# Technology Inclusive Content of Application Project Public Meeting

August 17, 2021  
Microsoft Teams Meeting  
Bridgeline: 301-576-2978  
Conference ID: 934 684 217#

# TICAP Public Meeting

Proposed Industry Principal Design Criteria

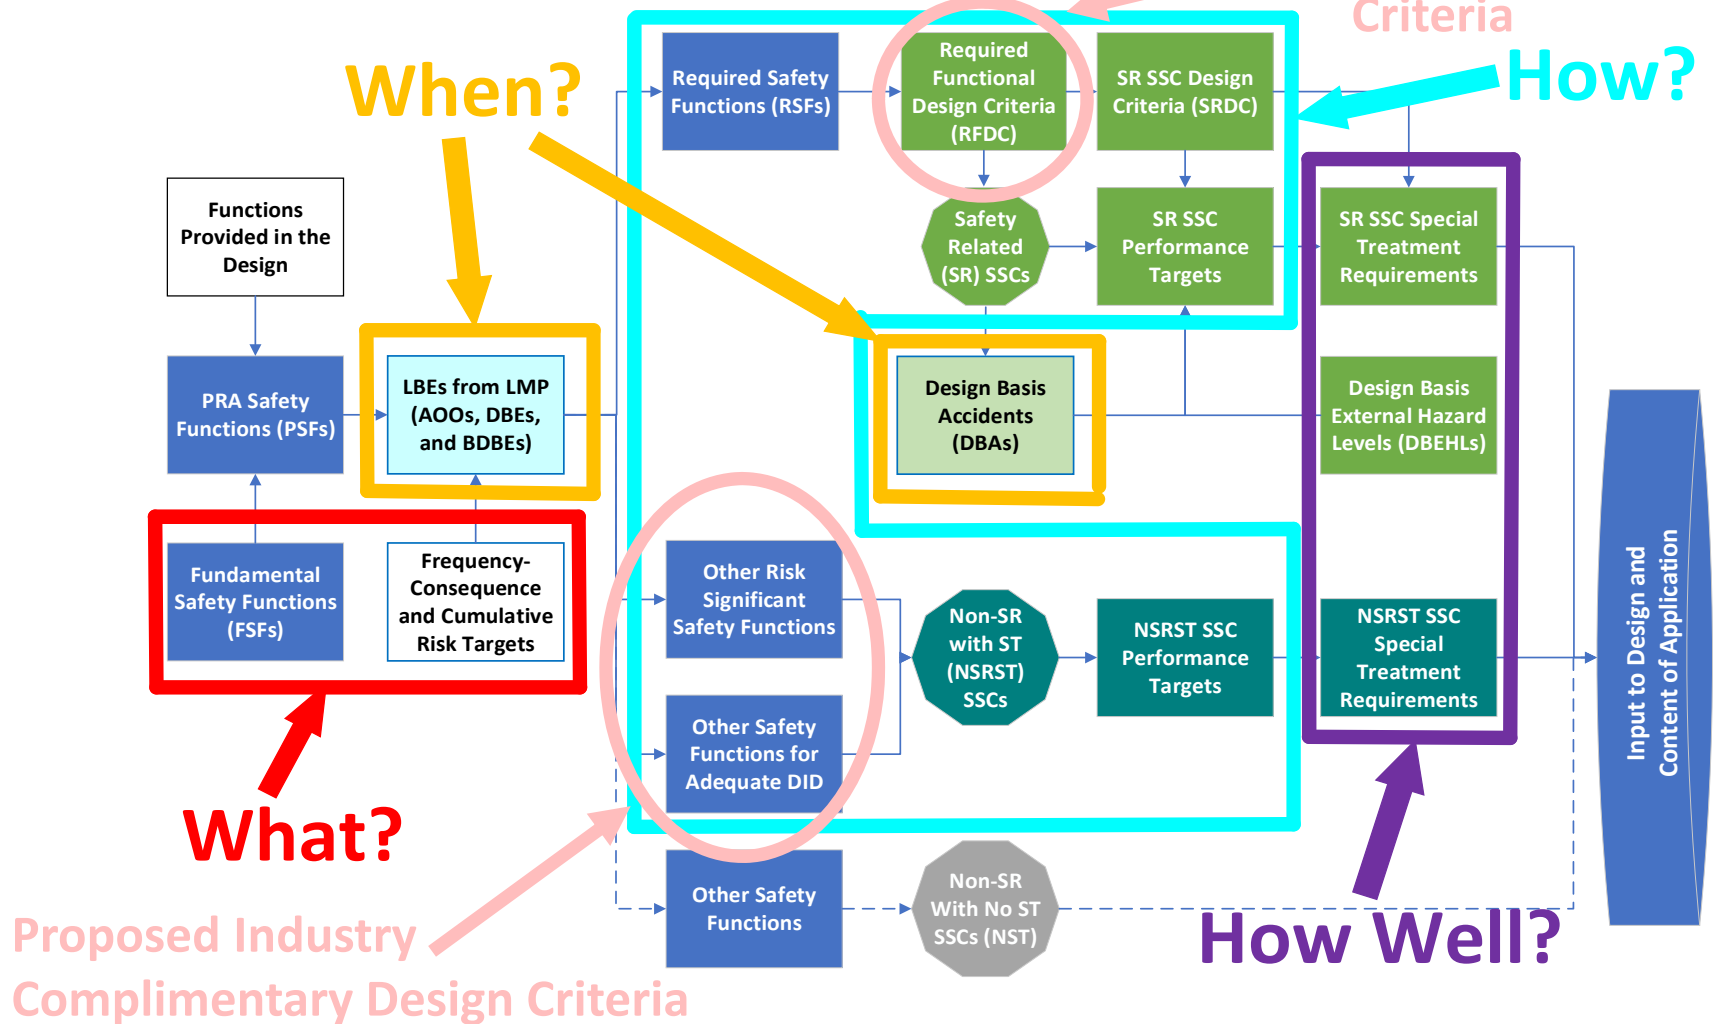
- The NRC staff is still reviewing the Industry White Paper and the question on whether an exemption request is needed regarding the purpose of PDCs
- At issue is the industry proposal to equate the Required Function Design Criteria (RFDCs) in NEI 18-04 to PDCs. As stated in the Industry White Paper, the RFDCs address the "How" portion of the design, whereas historical PDC address both "How" and "How Well."

- The NRC staff is considering the following options to move forward on TICAP guidance while the PDC issue is under review:
  - The NRC staff's draft TICAP Regulatory Guide white paper may be updated after considering the following options:
    - The LMP-based approach provides an acceptable approach for identifying PDCs associated with off-normal conditions
    - Review the applicant's proposed treatment of areas associated with normal operations and areas associated with proposed special treatments (e.g., quality assurance, protection from external hazards, testability, inspectability) and identify if PDCs, as well as proposed complimentary design criteria (CDCs), are appropriate in this area.
    - The LMP-based approach cannot be reconciled with the current PDC framework under 10 CFR Parts 50 and 52, and an exemption may be required.

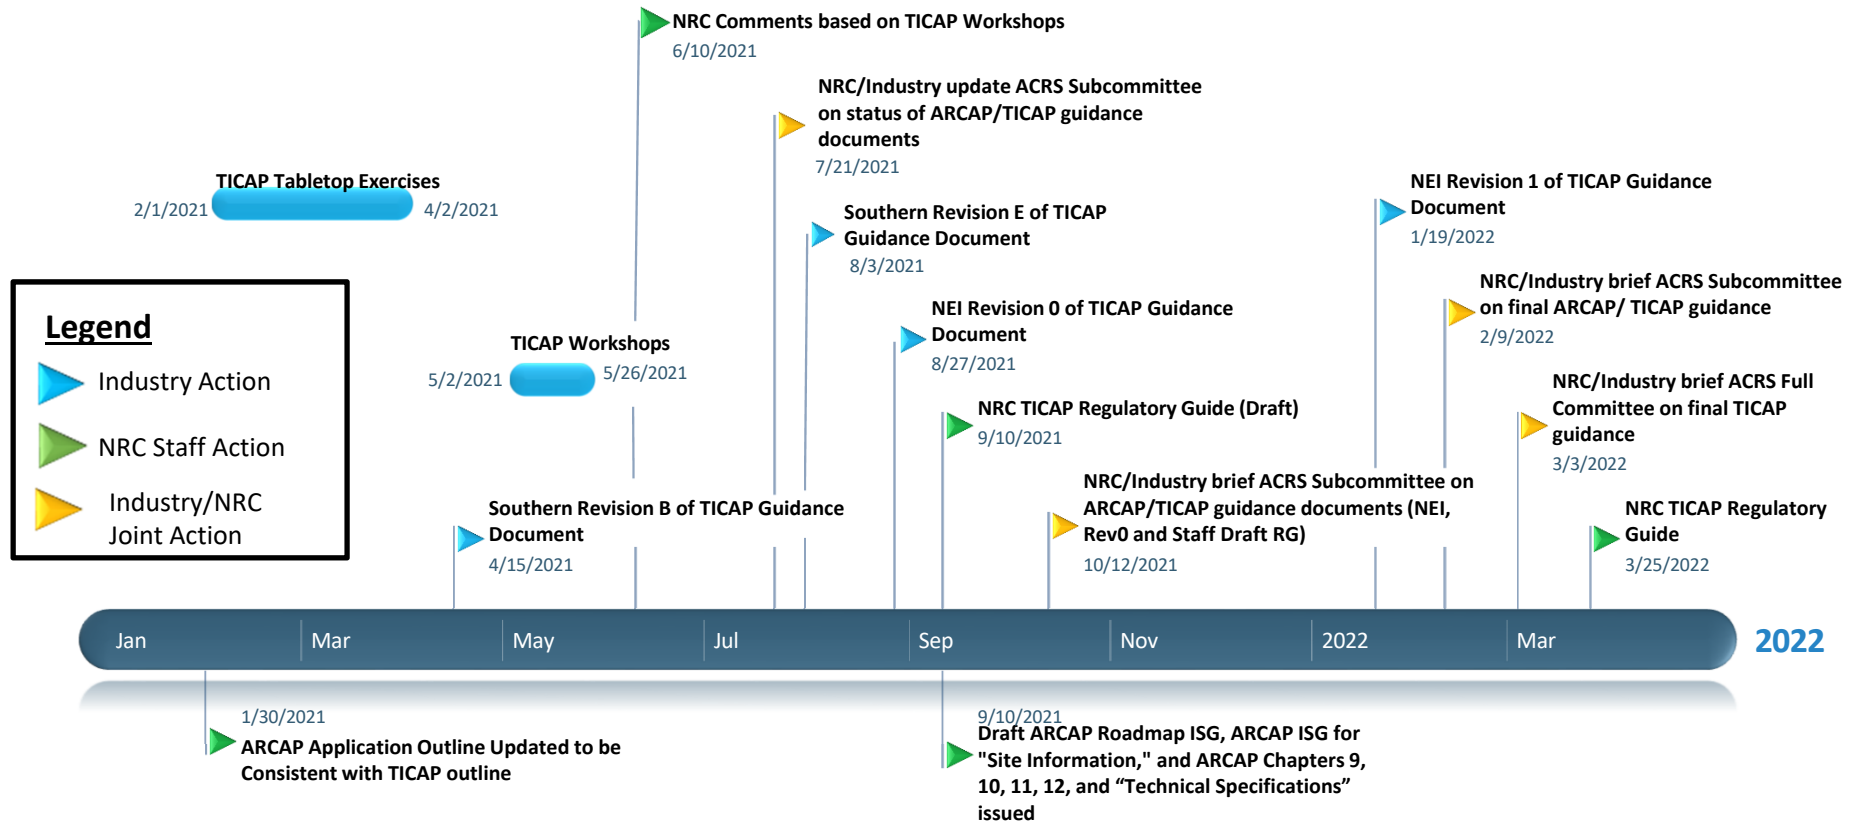
- Safety-Related SSCs (Section 5.4 – page 50)
  - The NRC staff does not agree with the industry guidance that appears to suggest that not all of the DID features are in the design basis (i.e., not in the SAR).

- Complimentary Design Criteria (CDCs) (Section 5.6 – page 54)
  - Why aren't the CDCs that are necessary to achieve the success criteria established in the PRA considered to be a part of the PDCs, and included in that category for the NRC staff review as a part of the safety assessment process?
